RE: Comment Letter to RDEIR/S – California Water Fix

**SolAgra Water Solution – previously known as: West Delta Intake Plan
Viable Alternative to BDCP/ CWF**

SUBJECT: Technical Comments on Bay-Delta Conservation Plan Modeling

Figure 8. NAA-LLT and Alt 4-LLT Simulated H Street Flow

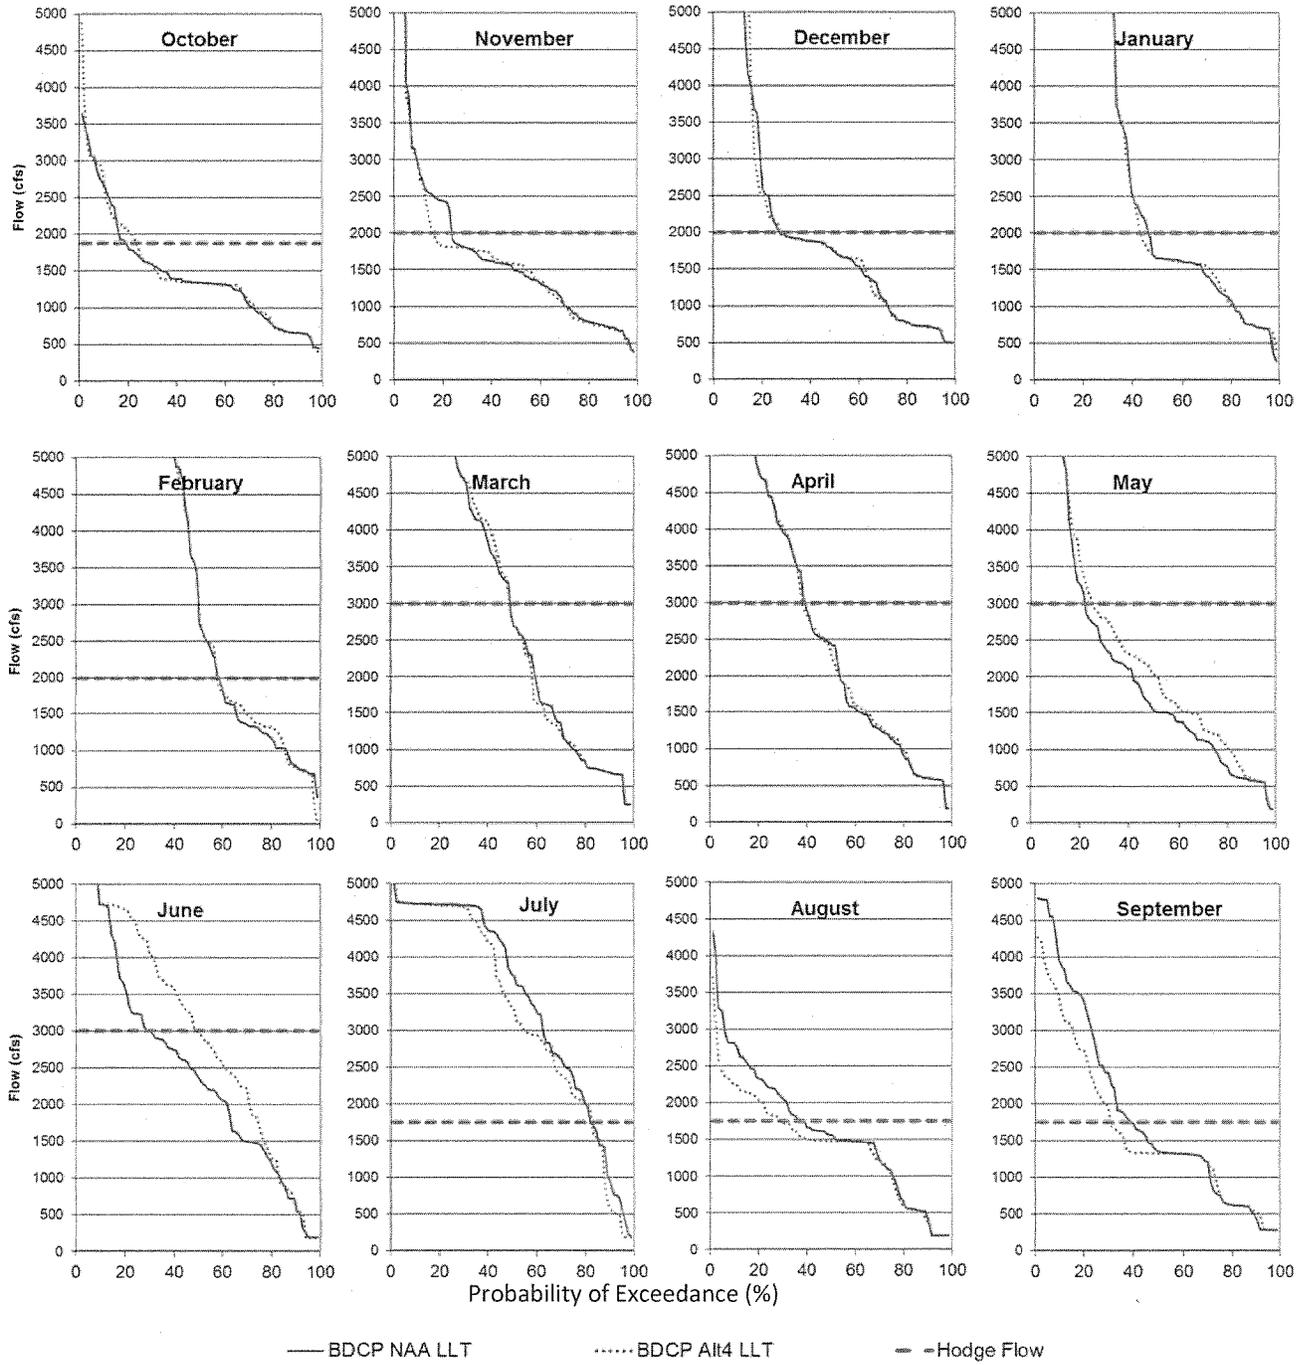
Figure 7 and Figure 8 contain comparisons of simulated monthly flow at Nimbus and H Street for the NAA-LLT and Alt4-LLT scenarios. Results show that under the Alt4-LLT American River flow is higher in the months of May and June, and lower in July, August, and September. Higher releases in May and June drive changes in Folsom storage and water surface elevation seen in previous figures. Likewise, lower releases from July through September bring simulated end-of-September storage between the baseline and with-Project scenarios closer. BDCP modeling shows a higher probability of Lower American River flows being above Hodge Flows in May and June and a higher probability of flows being below Hodge Flows in July, August, and September. When Nimbus releases are below Hodge Flows, diversion limitations under the City of Sacramento's American River water right permits for the Fairbarn Water Treatment Plant on the American River constrain the amount of water available to divert. The changes in American River flows will affect the location of the City of Sacramento's diversion, but this is not reflected in the BDCP modeling. There are also limitations on the City's Sacramento River diversion capability, which could interfere with any such shift in the location of diversions, and hence reduce the supply available to the City. This is not reflected in the BDCP modeling. In the Alt 4-LLT the City of Sacramento will be able to divert more water from the American River at Fairbairn during May and June and less during August and September.

Flow in the lower American River at H Street drops below 500 cfs in both the NAA-LLT and Alt4-LLT. This is critical for the City of Sacramento because their ability to divert water from the American River is affected when flow at H Street falls below 500 cfs due to the potential for pump cavitation. There are times when American River at H Street falls below 500 cfs more often in Alt 4-LLT than in the NAA-LLT. Water availability to the City of Sacramento, including under its settlement contract with Reclamation¹⁴, would be curtailed or eliminated on the American River when water levels in Folsom Reservoir drop below to dead pool level of 90,000 AF.

Figure 9. NAA-LLT and Alt 4-LLT Simulated Sacramento River Flow at the American River

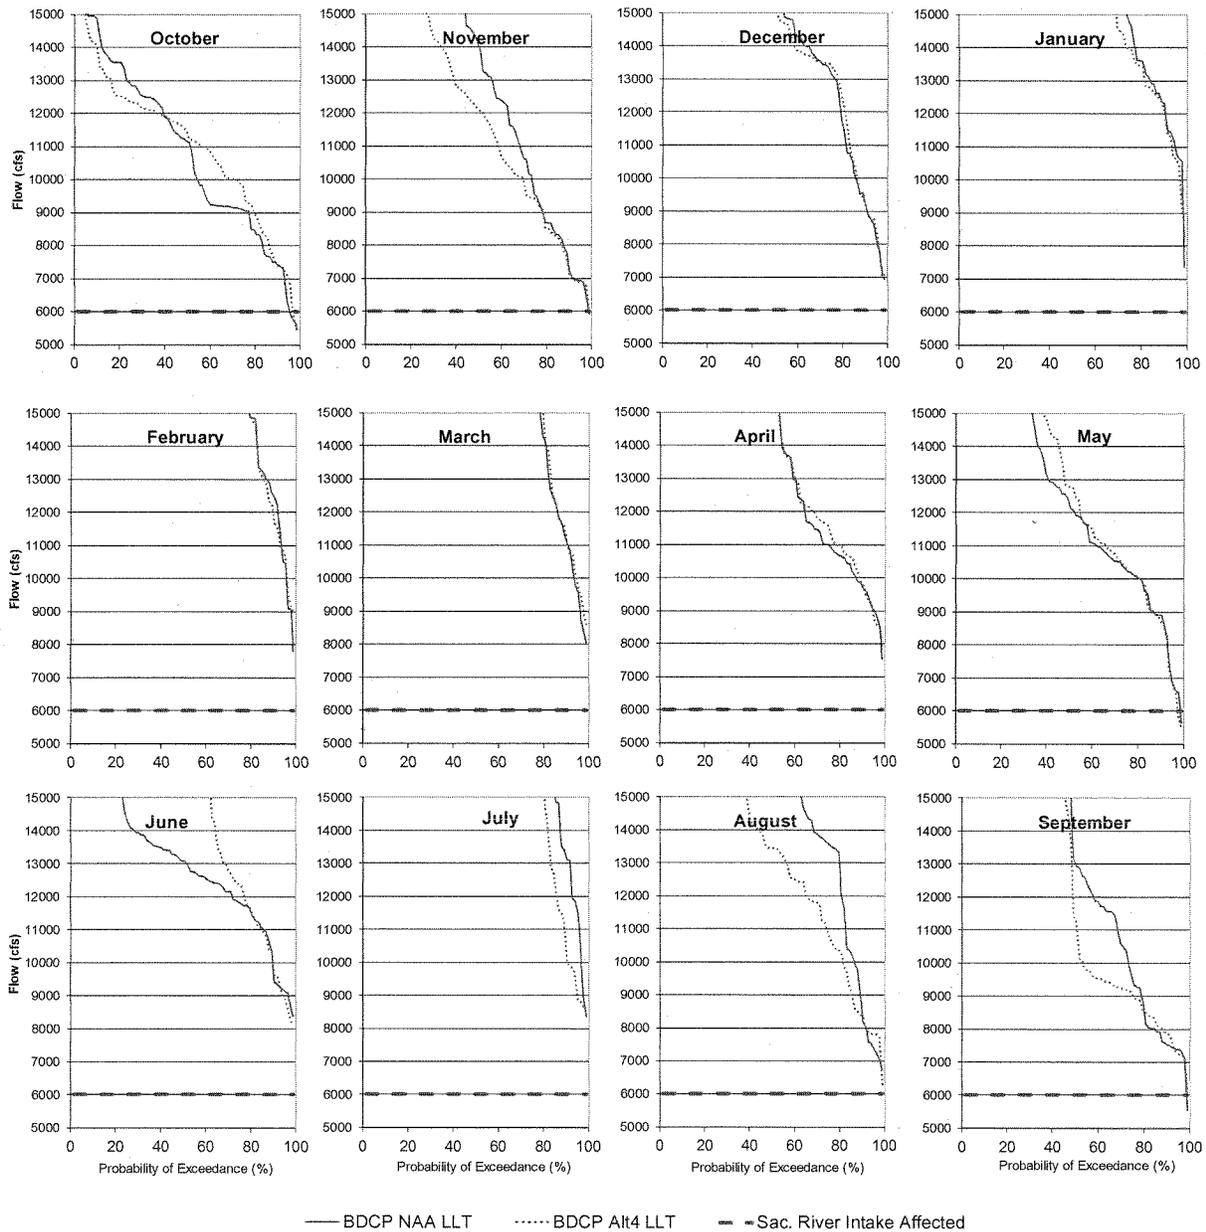
Figure 9 contains comparisons of simulated monthly flow in the Sacramento River at the confluence of the American River for the NAA-LLT and Alt4-LLT scenarios. When Sacramento River elevation falls below two feet above sea level (NGVD 1929) the City of Sacramento's intake structure capacity is reduced. Elevation 2.0 occurs when the flow rate is between approximately 5,000 cfs and 9,000 cfs and depends on tidal variation. Moreover, flow rates below 5,000 cfs may result in cavitation or vortexing, causing significant pump damage. Based on CalSim II modeling results, the frequency of the Sacramento River falling below 6,000 cfs is similar in the NAA-LLT and Alt4-LLT.

Figure 10. CVP North of Delta M&I Water Service Contract Allocation

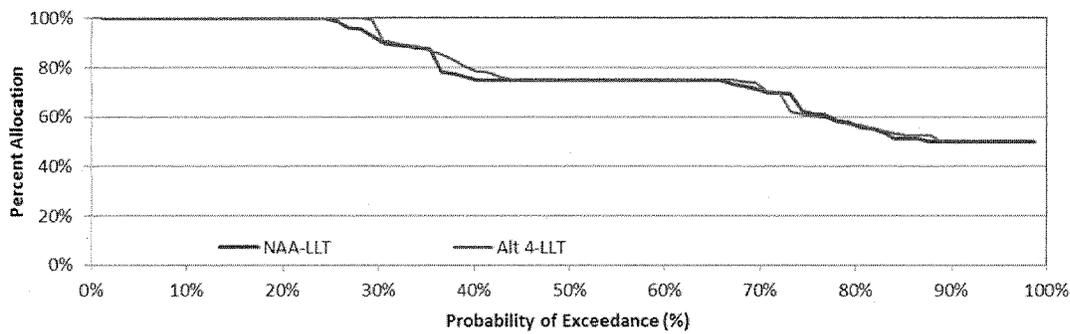
Figure 10 is an exceedance probability plot of CVP North of Delta M&I Water Service Contract Allocation for the NAA-LLT and Alt4-LLT. Changes in these allocations would affect the numerous CVP water-service contractors in the American River Basin, including the cities of Folsom and Roseville, Placer County Water Agency, SMUD and Sacramento County Water Agency. Average annual allocation to CVP M&I water service contractors is about 78% and increases by about one half of one percent in Alt 4-LLT compared to NAA-LLT. Although allocation never falls below 50%, deliveries are not always met due to low reservoir and river flows

Figure 5a. Summer (July - October) Monthly Mean End-of-Month of Storage Folsom Reservoir Storage (TAF) under the Existing Condition, No Action Alternative, and Preferred Alternative (Alternative 4).

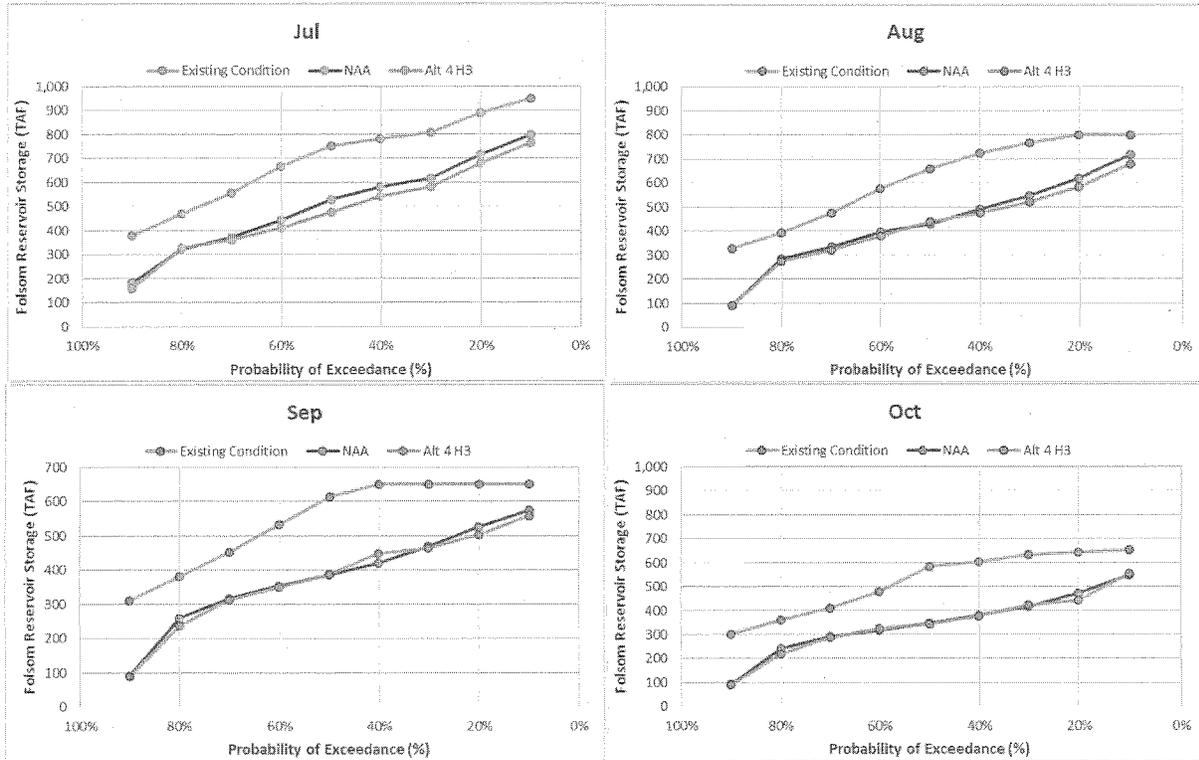
The operation of the CVP/SWP as modeled in the NAA with the sea level rise, climate change, and future demand assumptions results in much lower Folsom Reservoir storage elevations compared to existing conditions (Figures 5a and b) and greatly increased LAR water temperature. The frequency of Folsom Reservoir being at low storage levels (e.g., <350 thousand acre-feet [TAF]) would increase substantially in July and August under the NAA compared to existing conditions (increases from about 10% of the time under existing conditions to about 30% of the time under the NAA) (Figure 5a). In critical years, mean monthly

Folsom Reservoir storage would be 119 TAF, 105 TAF, and 81 TAF lower in July, August, and September, respectively, than under existing conditions (down to 210 TAF, 165 TAF, and 159 TAF, respectively, under the NAA). Mean monthly storage in drier years would drop to less than 350 TAF in August and September under the NAA (>440 TAF under existing conditions) (Figure 5b). Further, the frequency of which Folsom Reservoir would be drained to dead pool storage would increase by about 10% (DWR et al. 2013; p. 5-61). This would result in greatly increased water temperatures in the LAR.

Figure 6. Folsom Reservoir Storage (TAF) in Relation to ATSP Temperature Schedule¹. Higher ATSP Schedules Correspond to Warmer Summer Temperatures. All Schedules Larger than 55 Exceed Summer Temperatures of 70°F.

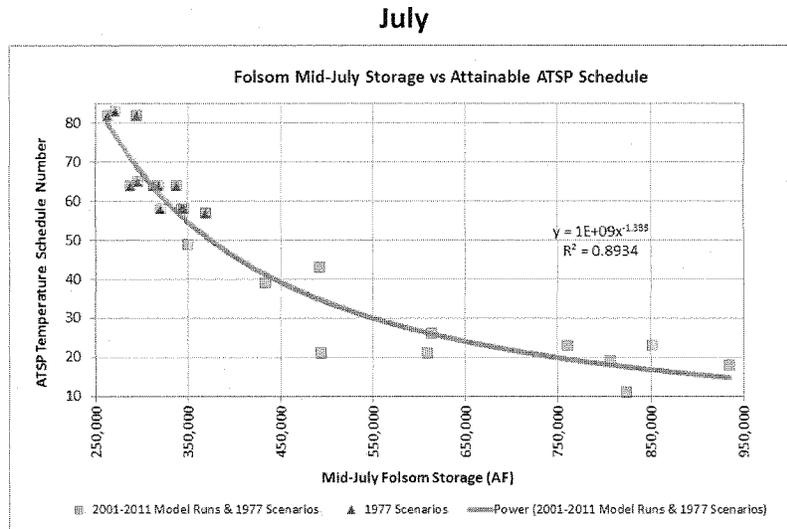
Higher American River summer temperature schedules occur when Folsom Reservoir storage drops, particularly as storage falls below 350 TAF in July. Figure 6 shows a relationship between the Folsom Reservoir storage in July and LAR water temperature schedules². Figure 7 shows relatively large increases in fall water temperature below Nimbus Dam at low Folsom Reservoir water levels as reported in the BDCP EIR/EIS (and the associated Folsom Reservoir storage) under the NAA operations. These changes are most pronounced in drier years.
